Date: February 12, 2024	REQUESTS:
Item #: P24-002	<p>The applicant is submitting a request for a Sketch Plan for a new 3-story, 280,000sf (total habitable) mixed use hotel building at the following 11 lots: 45 and 65 Mercill, 330, 350, 360, and 370 N Glennwood, and 325, 335, 345, 355, and 375 N Cache St.</p> <p>For questions, please call Tyler Valentine at 307-733-0440 x 1305 or email the address shown to the left. Thank you.</p>
Planner: Tyler Valentine	
Phone: 733-0440 ext. 1305	
Email: tvalentine@jacksonwy.gov	
Owners: Mogul Hospitality Partners-Jackson LLC PO Box 998 Midway, UT 84049	
Applicant: Same	
Please respond by: March 1, 2024 (with Comments)

RE: Sketch Plan Insufficiency: N Cache Lodging and Residential Development

RE: Sketch Plan Application: N Cache Lodging and Residential Development

RE: Miscellaneous Planning Request: N Cache Lodging and Residential Development

FLOOR PLAN - LEVEL B1

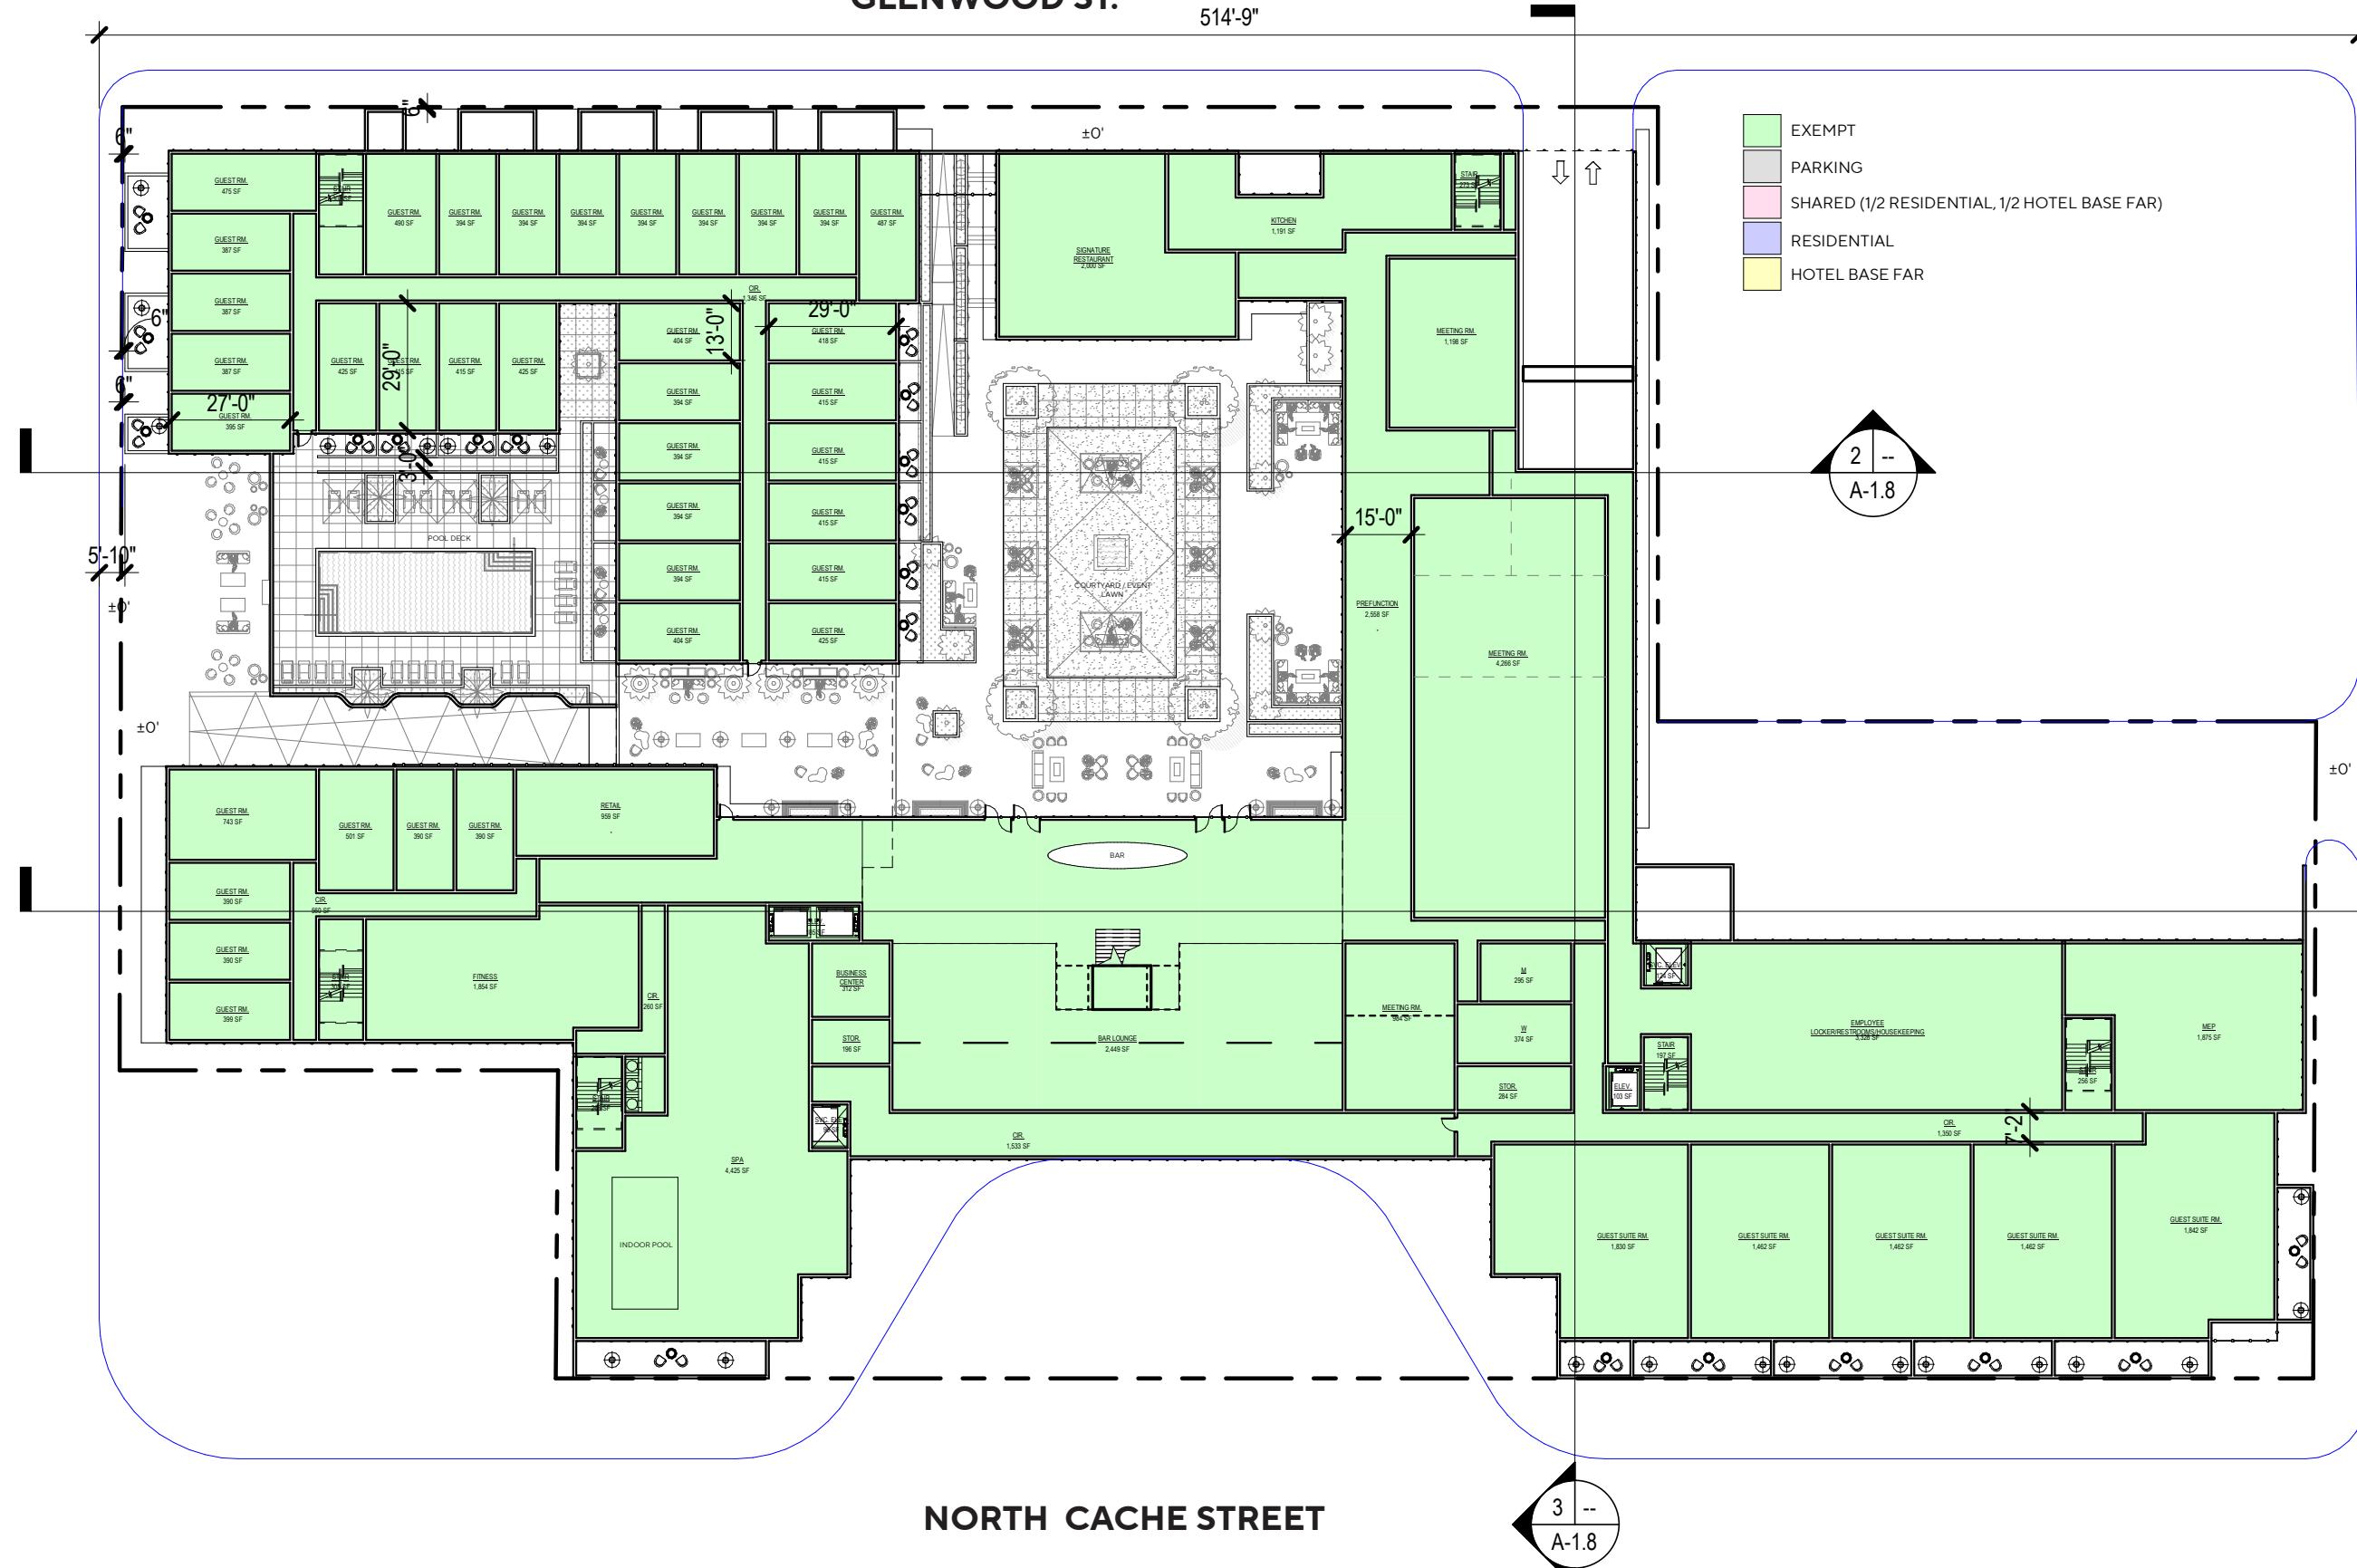
- a. Please see attached plan sets which incorporate the noted adjustment.
5. BASEMENT DEFINITION - Staff would like additional clarification on the floor plan for level B1. This appears to be represented as a partial basement level. Applicant needs

to clarify if it complies with the definition - "A basement is any story for which the finish floor of the story above is less than four feet above finished grade for at least 50 percent of the perimeter of the story and at no point greater than ten feet above finished grade." Based on the section plans this level is 6 above grade which does not constitute a basement.

- a. Please see attached plan sets which clarify. Mogul is happy to discuss any additional questions the Town may have regarding floor level B1.
6. ALLEY VACATION - If the Town Council approves an alley vacation or vacates a portion of the alley, and public access is allowed through the site from Mercill to Glenwood, the access path will need to be improved to better welcome and signal public access. As currently drawn, the public is likely not going to walk down the stairs to what appears to be a private hotel pool and then continue walking north past the pool through the small pinch point that is shown on the plans. In an attempt to provide meaningful public access, this area should be opened up so that it is clear to the general public that access is not only allowed but welcomed. The current plan does not accomplish that. Gaslight alley is a better example of welcoming the public through the site. Staff can discuss this further at the pre-application. The Town may require a public access easement for these same areas as a condition of any vacation of the alley.

ELEVATIONS

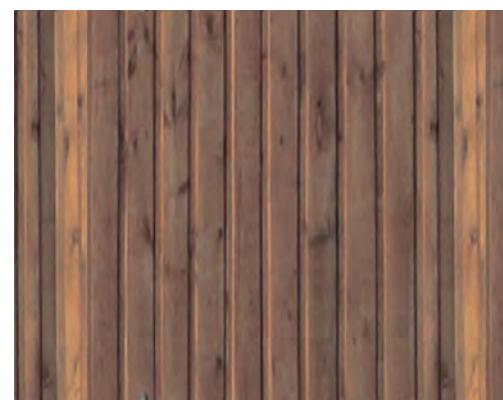
- **TOJ Comment #2:** *Although Sketch Plan is conceptual, 2D elevations are required. 2D elevations need to show height measurements along with callouts of the proposed exterior materials.*

- o **Applicant Response:** Please reference the updated submittal concept package, which includes the 2D elevations of the Project, including height measurements and callouts of proposed exterior materials.
